Access Compliance Report

Public Rights-of-Way

(Curb Ramps)

Intersection ID: 15323	Main Street: FANNIE_CR	Cross Street: GENE_AV	Location: N
ADA ID: A27BEF7F8689	Ramp Type: ParaDiag	Initial Pass/Fail: Fail	Overall Compliance: No
			Severity Score: 26.25

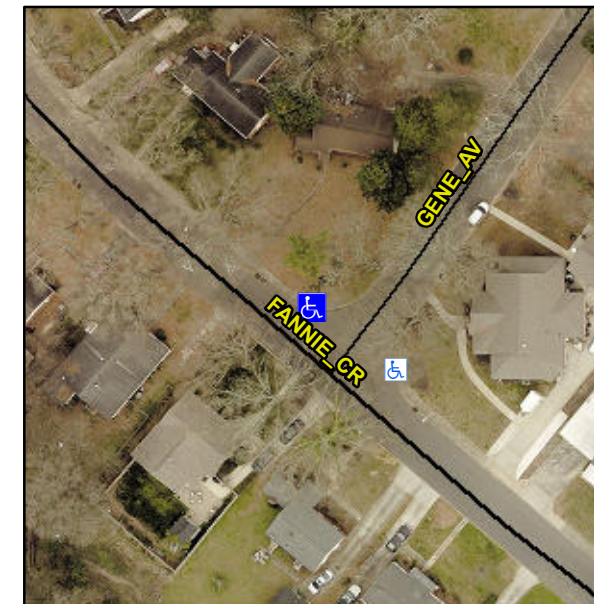
LT RP < 5%

R304.5.3, R304.3.2

Remove & Replace Curb Ramp With Two New Directional Ramps or Equivalent.
